Cabinet 18<sup>th</sup> December 2017

Item 3(b)

# Murton Gap Engagement Statement

December 2017

### South East Wildlife Corridor

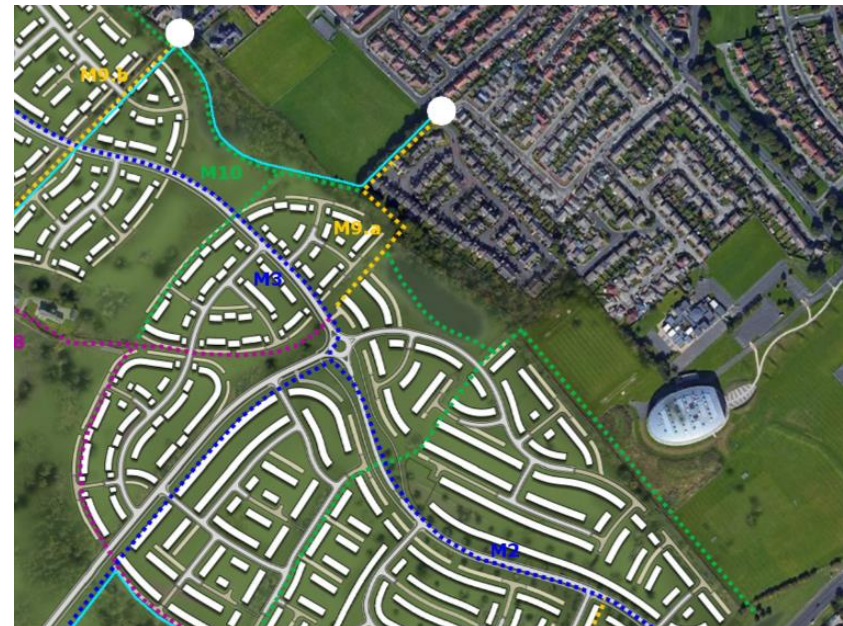
- Concerns about the width of the wildlife corridor to the south east corner.

**Draft Masterplan**

**Proposed final Masterplan**
